Access Compliance Report

Public Rights-of-Way

Intersection ID: 18844	Main Street: NATIONS_FORD_RD	Cross Street: TYVOLA_RD	Location: NE
ADA ID: AEB524E9A574	Ramp Type: BlendTrans1	Initial Pass/Fail: Fail	Overall Compliance: No
			Severity Score: 18.75

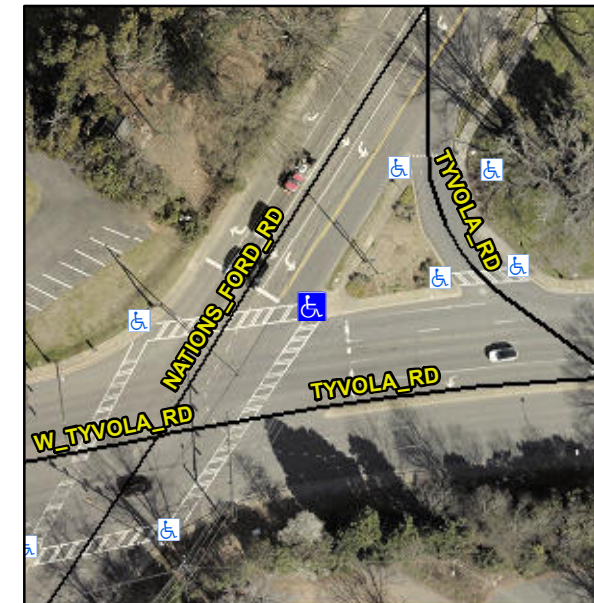
Surveyor Notes:

LOCATED ON ISLAND

PROW/ADA:

R304.5.1, R304.5.3

Possible Solutions:

Remove & Replace Curb Ramp With Two New Directional Ramps or Equivalent.
